CERTIFICATE OF APPROPRIATENESS

Property: 518 W 13th Street, E 69.2 ft of Lots 34, 35, & 36, Block 182, of Houston Heights Subdivision. The property includes a 1,592 square foot one-story bungalow single-family residence situated on a 6,920 square foot interior lot.

Proposal: Alteration/Revision—

Revision to previously approved COA, issued 2/22

RIGHT (west) ELEVATION—Revised Jan 10-2023

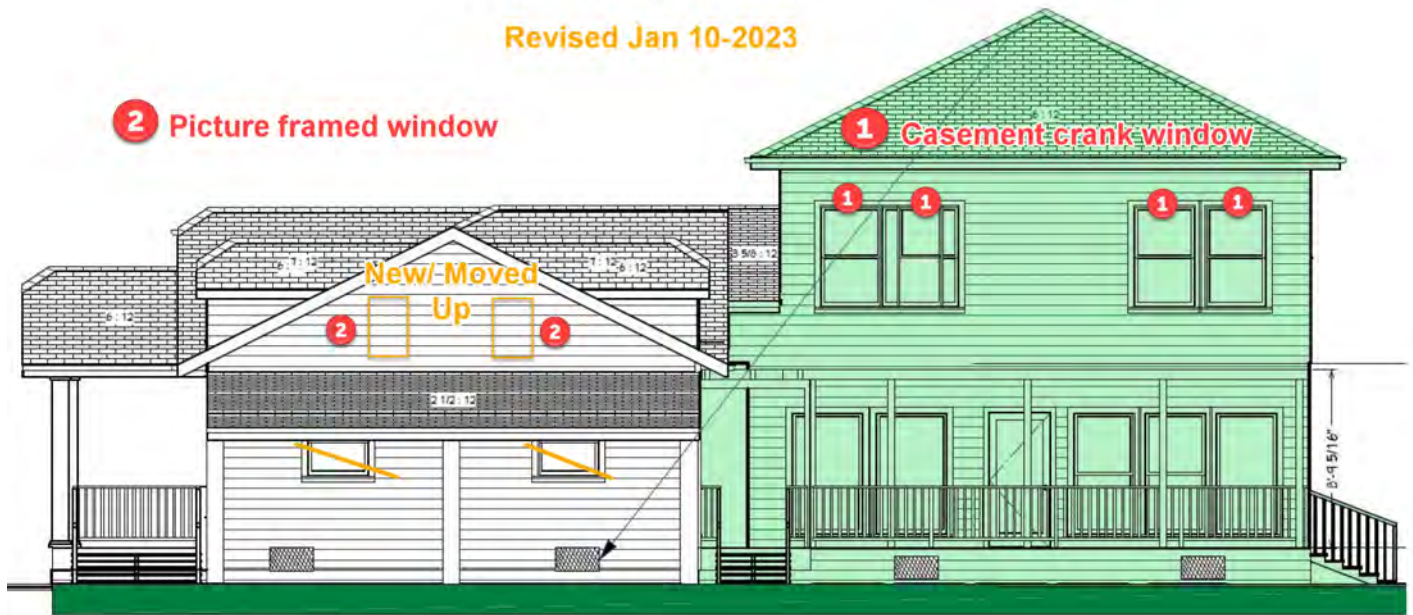
Figure 8 - View from Street of West Elevation with 2 new windows

LEFT (east) ELEVATION
& GARAGE—Revised Jan 10-2023

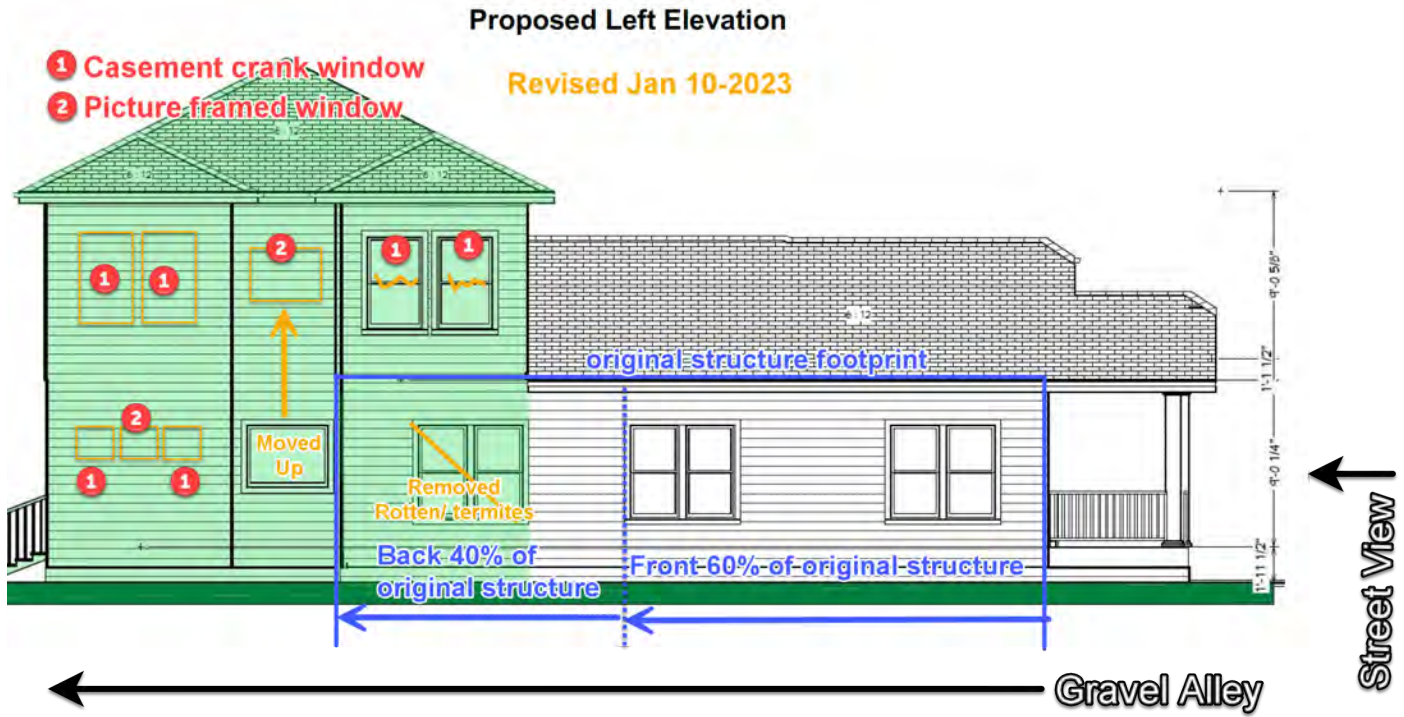
—Our original COA East Elevation drawing shows that there were two windows under the carport. However, there was actually only one. The previous owner said approx 17 years ago, he built/added the dormers and carport with 1 small window under the carport and a door over the carport.

- Dormer
- Stained Glass door
- Carport
- Garage window

Added approx 17-20
yrs ago

****GARAGE****
Revised Jan 10-2023

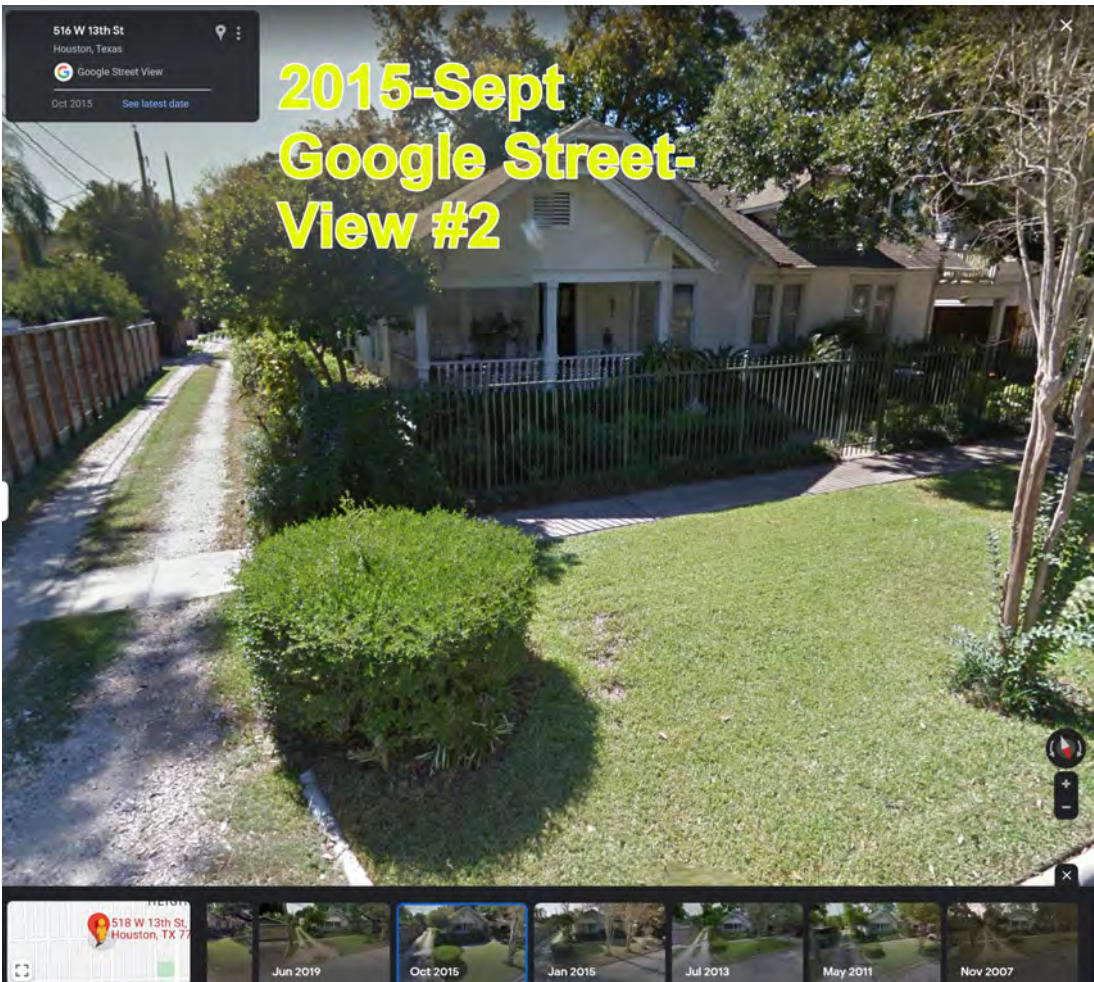
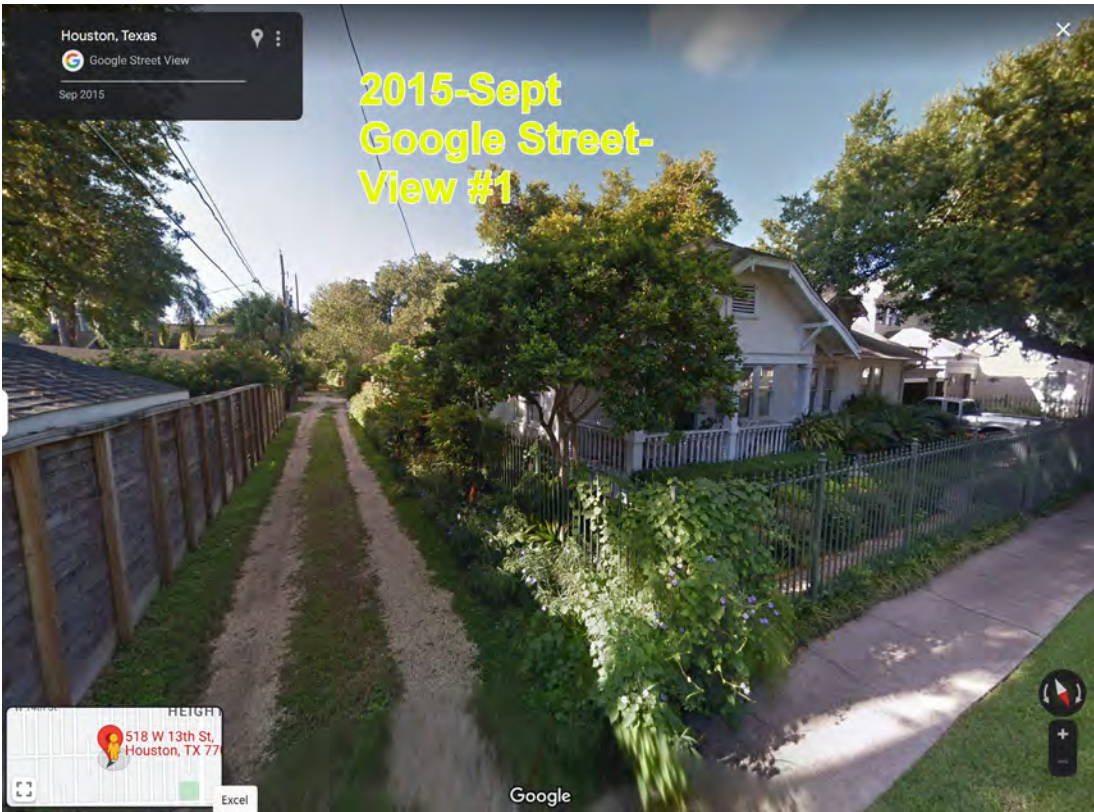
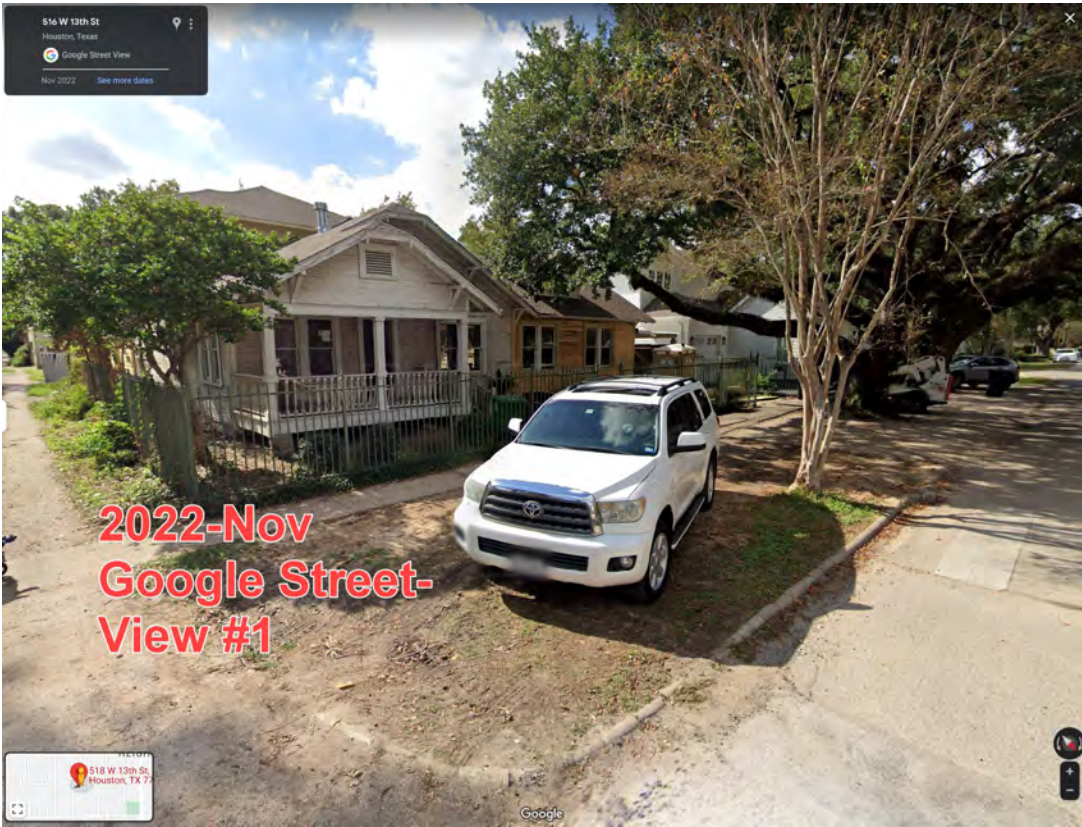
Recommendation: Denial - does not satisfy criteria AND issuance of a COR with the condition that the 2 pairs of windows on the 2nd floor, east elevation be replaced with 1/1, inset and recessed windows trimmed with historically accurate details as previously approved.

| <input type="checkbox"/> | <input checked="" type="checkbox"/> | <input type="checkbox"/> | (6) New materials to be used for any exterior feature excluding what is visible from public alleys must be visually compatible with, but not necessarily the same as, the materials being replaced in form, design, texture, dimension and scale; The newly installed single pain windows flush mounted do not have precedence among contributing houses in the district. |

2 Picture-framed window

1 Casement-crank window
